**Certificate of Appropriateness Application**  
BAR 15-10-08  
550 East Water Street  
Tax Parcel 530162300  
Neal Sansovich, Owner/ Andrew Baldwin, Applicant  
New Mixed-Use Complex

**CITY OF CHARLOTTESVILLE  
BOARD OF ARCHITECTURAL REVIEW  
STAFF REPORT  
October 20, 2015**

BAR 15-10-08  
550 East Water Street  
Tax Parcel 530162300  
Neal Sansovich, Owner/ Andrew Baldwin, Applicant  
New Mixed-Use Complex

**550 WATER ST MIXED-USE NORTH ELEVATION**

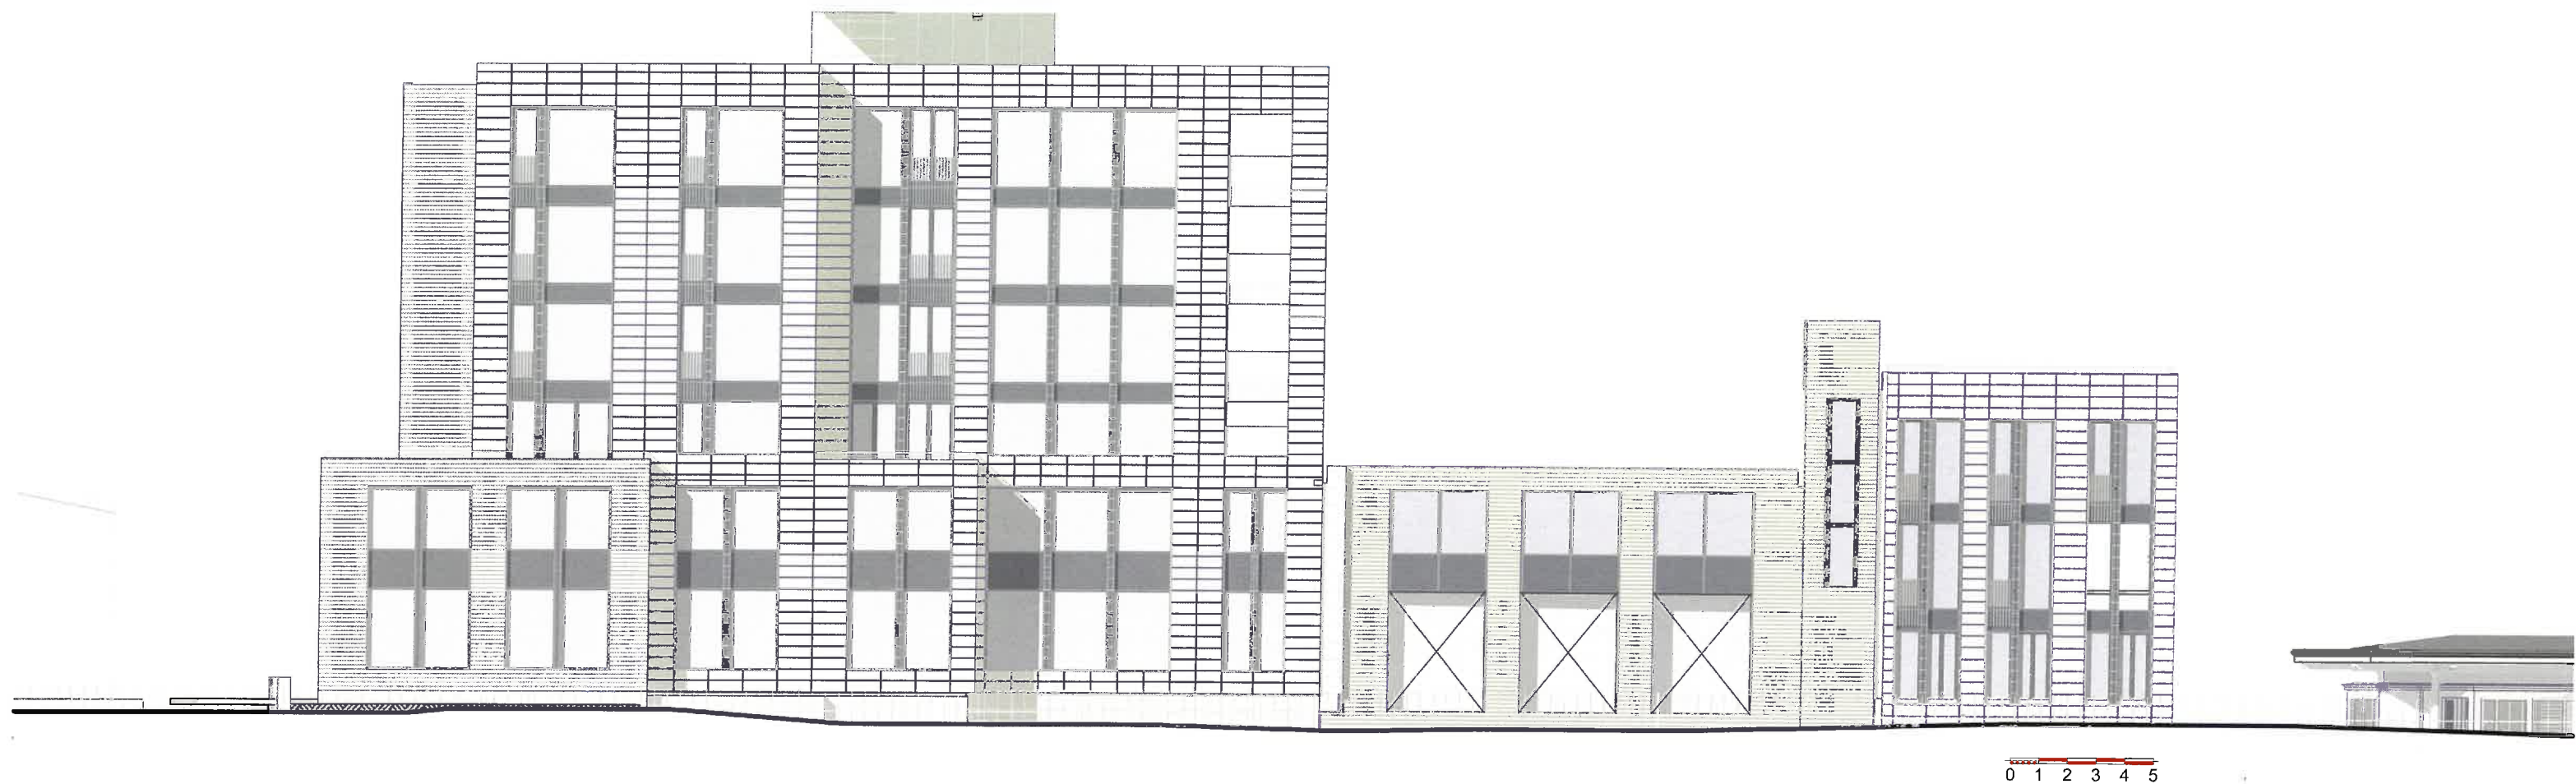
only. The current design correctly shows the maximum height called out to be 70 feet, measured to the flat roof, although the scale on the drawings is incorrect. The BAR should ask to see the west elevation included with future plans.
